TO: Historic Preservation Board

Item Number: 2

DATE: January 2, 2018

SUBJECT: Petition HP-17-71. Peter McNiece, owner. Howard McLean, agent. Application for Certificate of Appropriateness for exterior alterations to house, including front porch enclosure, side entry modification, rear entry and two new windows. Located at 520 SW 10th Street. The property is contributing to the University Heights Historic District – South.

EXISTING - ELEVATION - WEST
SCALE: 3/16" = 1'-0"

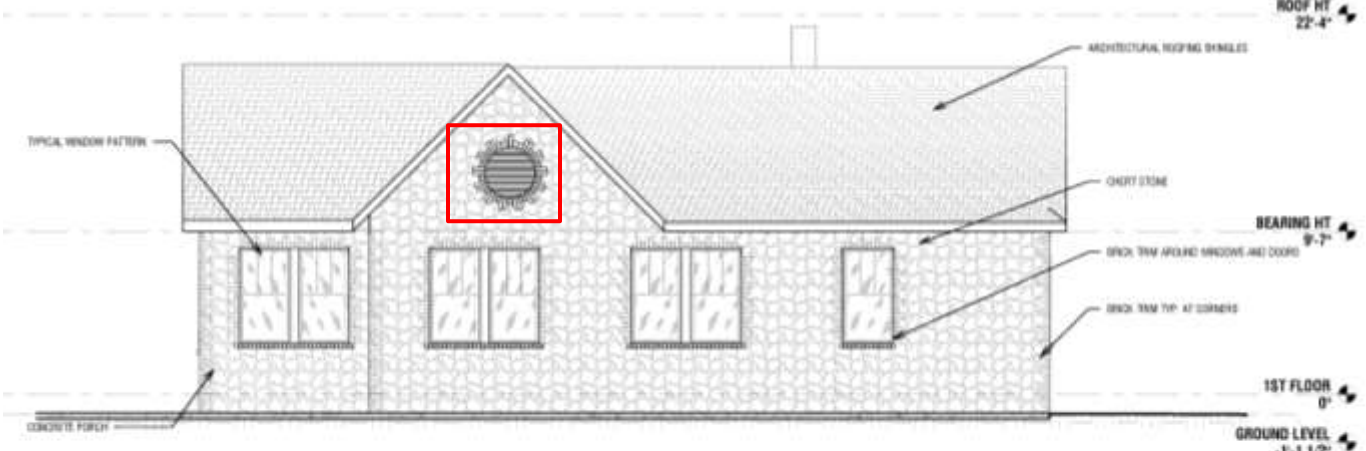
A new door and opening is proposed for the rear elevation, where a window will be removed and a new fiberglass door with glass will be installed.

Staff finds the proposal for the new doors and sidelights appropriate as the new designs of the doors with art glass maintain a clear distinction between old and new and the installation of the front and side doors does not destroy significant architectural features on the primary and secondary façade. Staff finds the proposal of the side entry with new wood shake panels compatible, as the existing is not historic and the new entry will be flush within the existing wall on the secondary façade of the house. For the rear entry, Staff does not find a new entry on the rear faced of the house objectionable but requests an elevation of the door installation that shows how the new opening will relate to the existing window opening with brick detailing. It is recommended that as much of the brick detailing be retained as possible.

- For the rear entry, submit an elevation of the door installation that shows how the new opening will relate to the existing window opening with brick detailing. It is recommended that as much of the brick detailing be retained as possible.
- For the new window at the front porch enclosure, use a wood, clad or fiberglass sash window, with 3/1 true divided lights and profiles to match as closely to the historic as possible. Submit window cutsheet and profiles for Staff review.
- For the attic windows, vinyl can be used as long as: the window trim around the window will match the dimension in depth and width of the existing vent trim, so that the window is well recessed into the masonry opening, and the glazing in the new windows shall not be mirrored or tinted glass. Submit window cutsheet and dimensioned trim detail showing recess for Staff Review.

PROPOSED EAST ELEVATION

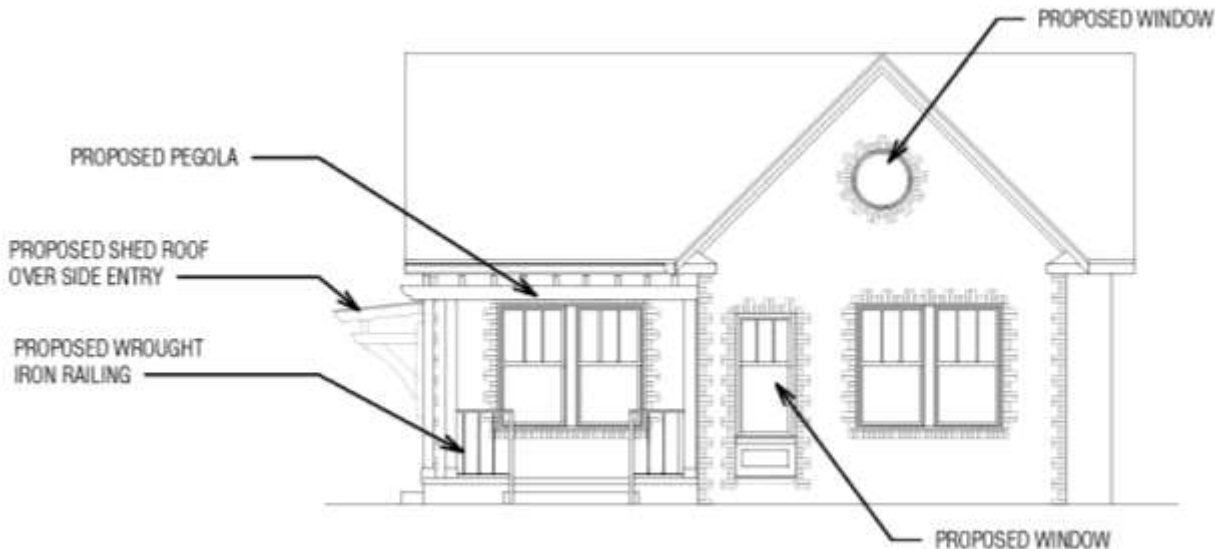
Staff finds the existing recessed entry is smaller than the porches that the guidelines refer to, and as such, enclosure for continued use as a covered entry is an appropriate use of the space. The proposal maintains the existing masonry openings with brick detailing, which are character-defining features of the house. The front opening will be infilled with a window to match the configuration of existing windows, as well as a small wood panel at the base, which signifies an infill better than new chert would. The new doors are located on the side of the recessed entry. Staff finds the proposal for entry enclosure appropriate as the work is compatible, retains the character-defining features of the house, and is removable without damaging the historic property.

Staff finds that the pergola over the front patio does not destroy significant architectural features and can be viewed as a landscape element as it is over an open patio. It is also positioned under the eave line of the existing roof, so its height does not change the existing outer form of the house. Staff finds the installation of the metal railing acceptable, though questions if wood wouldn't be more appropriate, as there is no other metal decoration on the house. Staff finds the side entry cover also appropriate as it is on the secondary façade of the house and is simple in design and does not detract from the cottage-character of the house.

Staff finds the proposal for a new vinyl window with internal muntins inappropriate per the guidelines as vinyl does not typically meet the profile depth of wood windows, the window does not have true divided lights, the window is on the front façade of the house, and the location of the meeting rail/ proportion of the drawn window does not match the existing windows. Further, as the window is for a new infill of the porch enclosure, it should be compatible with the historic windows adjacent to it. The existing windows of the house are wood, 3/1 double-hung with true divided light. Staff recommends a wood, clad or fiberglass sash window, with 3/1 true divided lights and profiles to match as closely to the historic as possible. As the new window will match existing in proportion and meeting rail location, Staff finds the wood panel at the bottom of the infill appropriate.

PROPOSED SOUTH ELEVATION

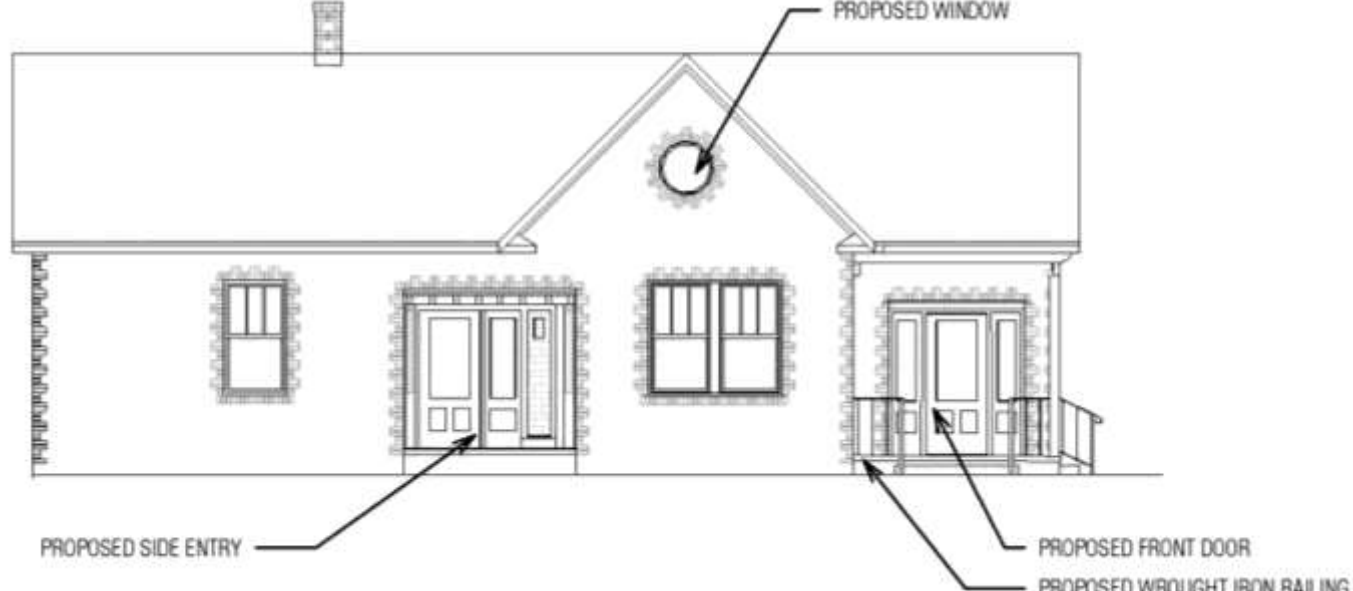
The new side entry door will also be fiberglass with glass and one sidelight. The side door and stucco bay on the south facade is not original. The new side entry will also contain a small panel of wood shakes, a material seen in a similar chert house at 1122 SW 3rd Avenue in the same historic district.
